## **TECHNICAL MEMORANDUM**

**DATE:** February 15, 2011

**SUBJECT:** *Review of Groundwater Investigation Work Plan Part I: Field Investigation Activities Bulk Fuels Facility Spill Solid Waste Management Units ST-106 and SS-111, dated November, 2010*

Figure 1. Existing and proposed monitoring well locations (Figure 3-1 from Shaw, 2010c).

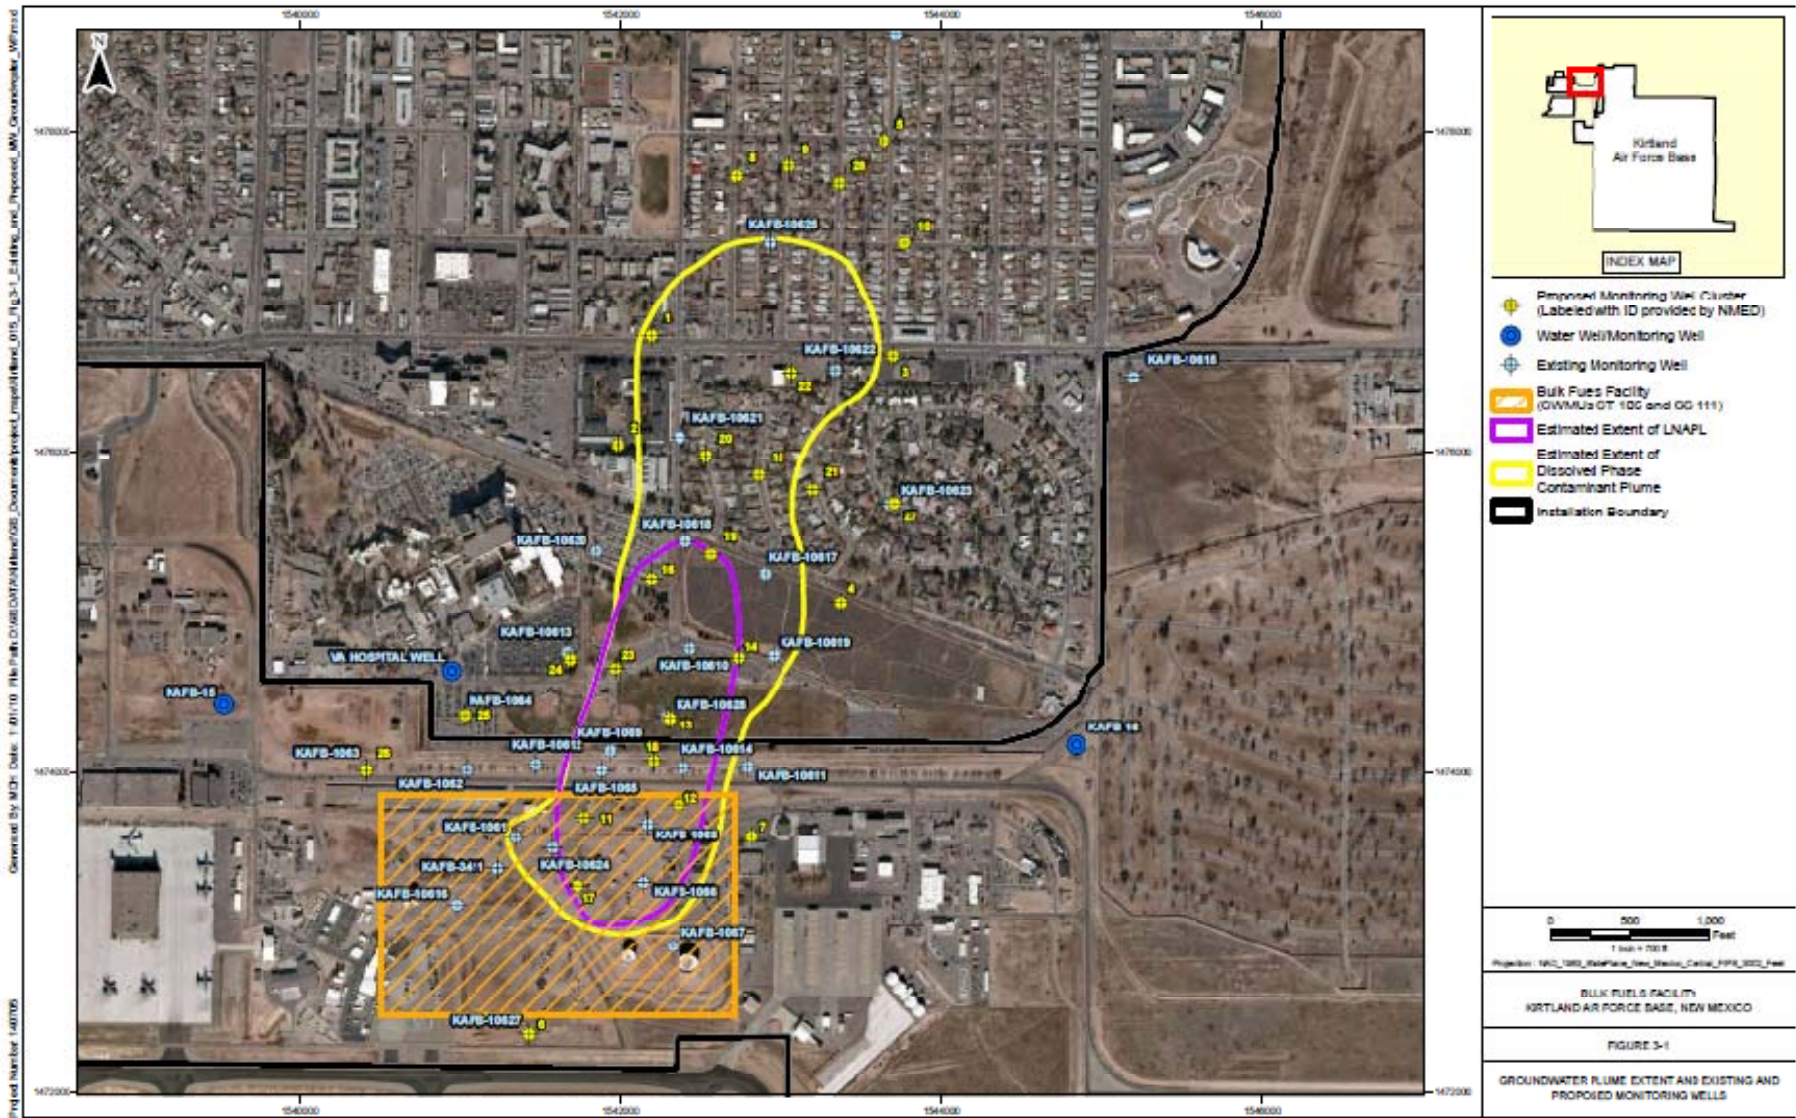
For example, the work plan (as directed by NMED) proposed installing wells in the margin of the LNAPL lens (and specifically intended to determine dissolved-phase extent) to depths no deeper than 55 ft below the water table, whereas wells to be installed within the LNAPL lens are to be constructed with screens no deeper than 100 ft below the water table. ABCWUA (Water Authority) wells in the vicinity of the plume are screened as deep as approximately 3,000 ft bgs, so that deeper screens are more likely to be necessary outside the LNAPL lens, rather than inside, in order to detect the obliquely downward movement of the dissolved phase plume to the supply wells. Thus on first principles, the dissolved phase wells outside the LNAPL lens should have an additional screened interval deeper than 55 ft below the water table if KAFB/Shaw believe there is evidence to require the 55 ft below the water table screen depth.

If any of the proposed deep wells reveal detections of jet-fuel-related compounds, installation of additional wells is recommended. Similarly, the side- and down-gradient boundaries of the plume may not be defined simply by the proposed monitoring wells; however, this will not be known until the proposed wells are installed and sampled.

With respect to soil sampling, the work plan limits soil sample collection to the deepest boreholes at NMED well locations 11, 12, 17, and 18, all within the LNAPL lens. Excluding sampling at the remaining 24 well locations will provide a very limited understanding of the geologic and hydrogeologic properties of the affected aquifer. With such limited information, the work plan is not likely to achieve its stated objective to characterize the geologic and hydrogeologic properties of the aquifer.

Wells located outside the LNAPL lens should have screened intervals for at least one more depth interval below 55 ft beneath the water table to ascertain the vertical distribution of dissolved phase contamination.

Consider a phased approach that includes provisions for additional monitoring well installations if the plume boundaries are not effectively delineated via the current set of proposed wells.
